WILLIS AVENUE/SEMET TAR BED IRM
TIE BACK WALL/ENGINEERED FLOODPLAIN

INTERIM REMDIAL MEASURE
WORK PLAN

RESPONSES TO NYSDEC COMMENTS ON THE

WILLIS LAKESHORE SUBSURFACE BARRIER WALL STABILIZATION DESIGN

FIGURE 4.1
WILLIS SEMET IRM
TIE BACK AND ENGINEERED FLOODPLAIN

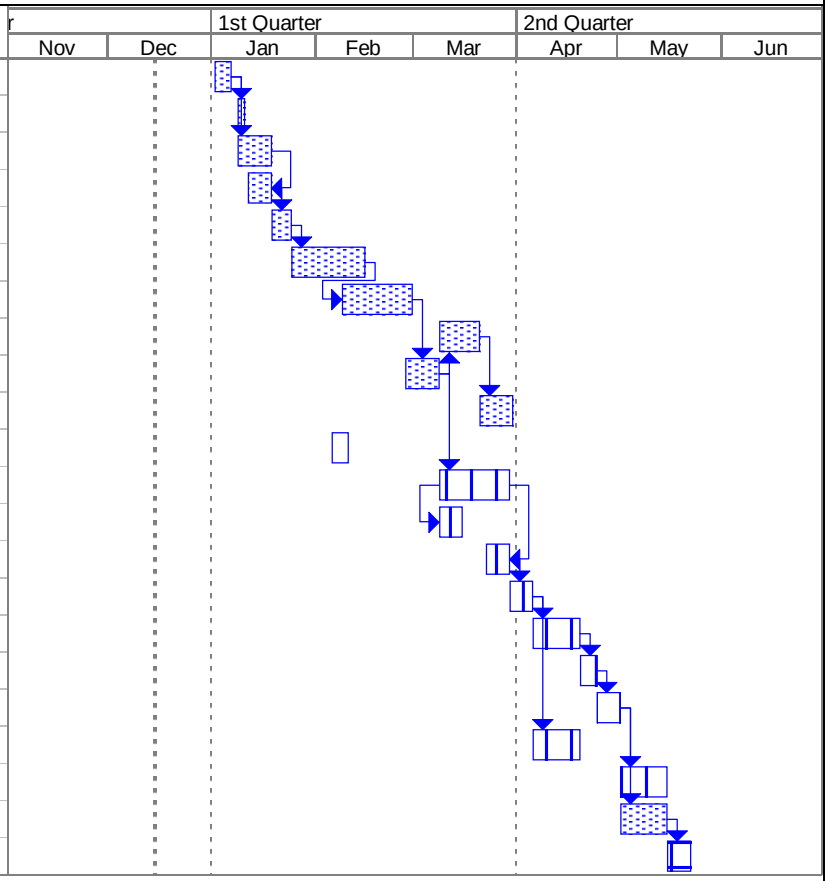
6. The construction work plan should include a schedule for completing the work.
   A construction schedule is included as Figure 4.1 of the IRM Work Plan.
